**Tooheys Brewery,
Lidcombe -
Cogeneration Facility**

Response to
Submissions

November 2009

Figure 5-1: Heat Radiation vs. Distance Plot for a Torch Fire Scenario inside the Engine Room

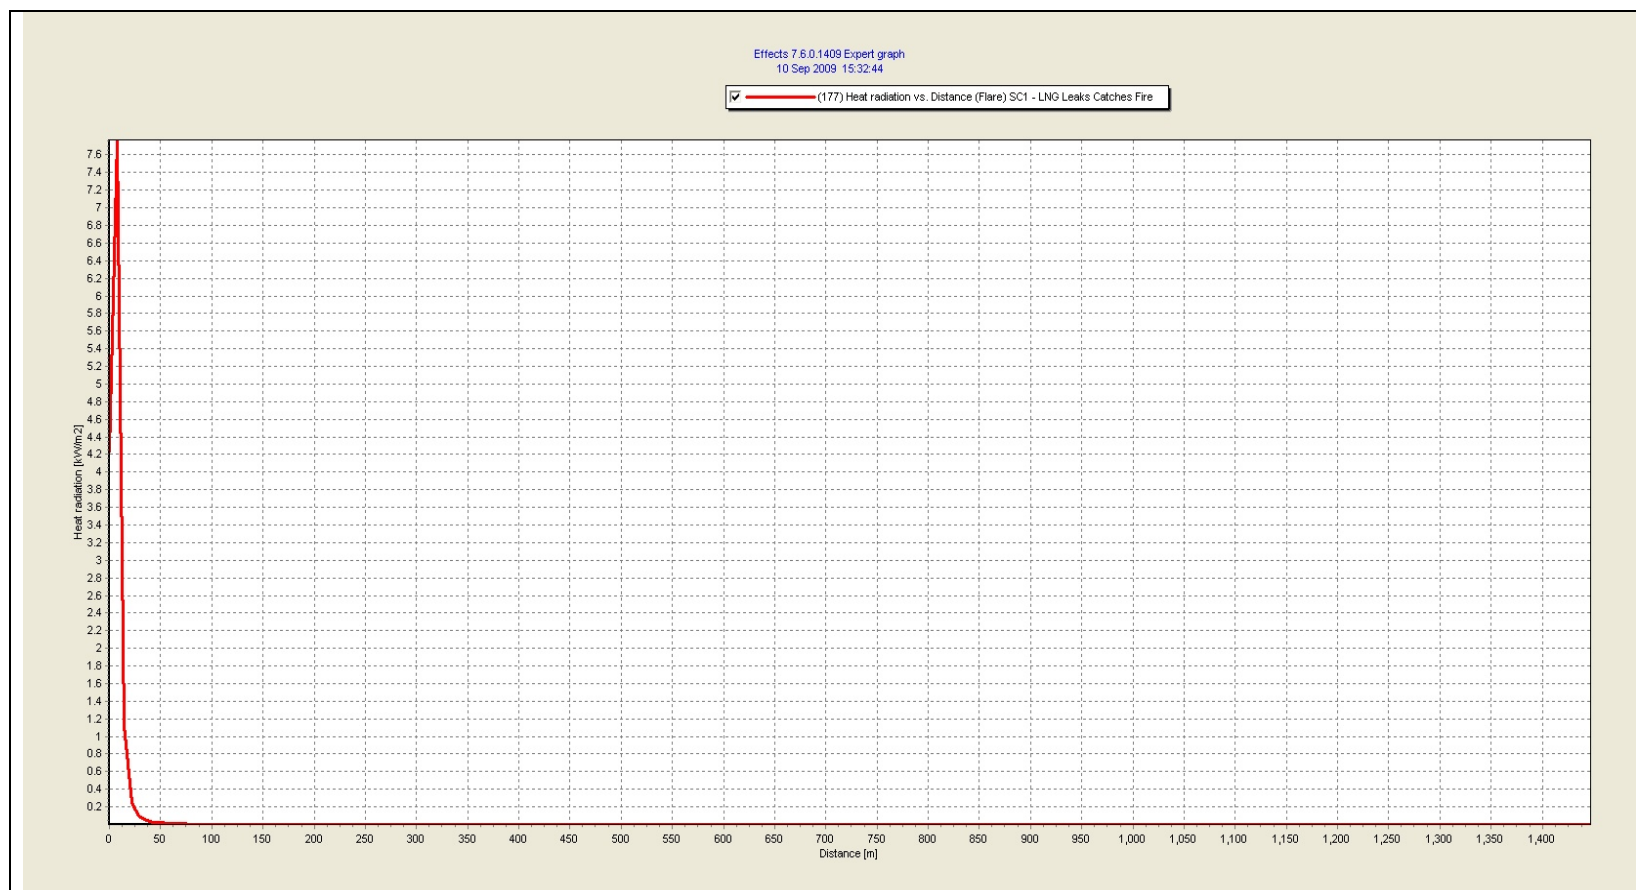
- v Fig 5-2 Heat Radiation vs. Distance Plot for Fire inside the Engine Room shows a heat radiation of 4.4 kW/m² at the edge of the fire and a maximum of 7.8 kW/m² at greater distance from the fire. This again is surprising and some explanation should be provided.

With a jet flame, the max heat flux occurs at a certain distance rather than at the point of release. This is because the gas being released needs time to completely mix with air before it gets burnt. . Since it came out as a jet, the gas would be at ambient temperature at a distance very close to the hole. Any fire close to it will be pushed away by the gas being released. In addition, it also needs time to achieve elevated temperature required for fully developed flame.

Figure 5-3: Overpressure vs. Distance

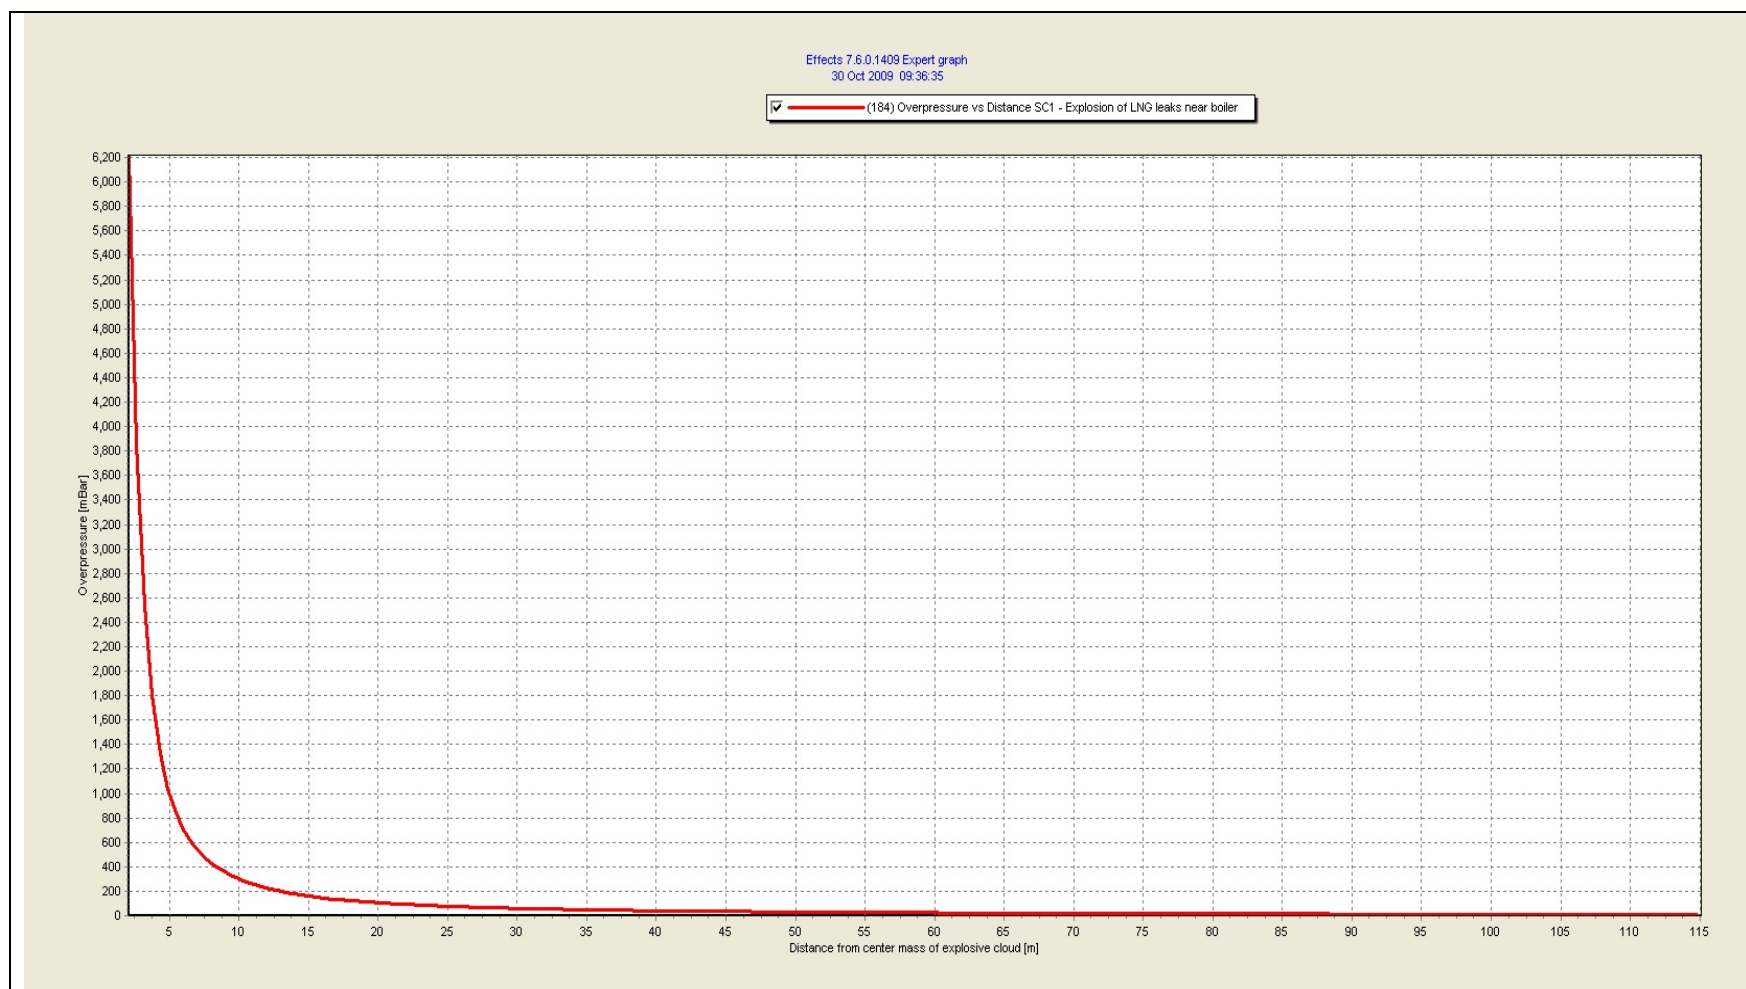
- a. The cogeneration plant will be installed in an enclosed area (the engine room). In relation to this matter:
 - i Why have possible accidents resulting in flash fire or explosion not been considered in the risk assessment? In case of a credible scenario, the domino effects on the surrounding equipment and storage (including Depot F1-F5, ammonia storage) should be taken into account.;

Although unlikely, an explosion scenario has been modeled and presented in the Addendum Report. The predicted overpressure level at the ammonia tank is around 116 mBar (or 11.6 kPa). To cause a structural failure to the ammonia tank, the level of overpressure needs to be close to 210 mBar. Given this prediction, a domino effect from the explosion scenario is unlikely.

The overpressure level at the closest residence is around 10 mBar (or 1 kPa). This readily satisfies the explosion overpressure criteria at residential area, which is 70 mBar.
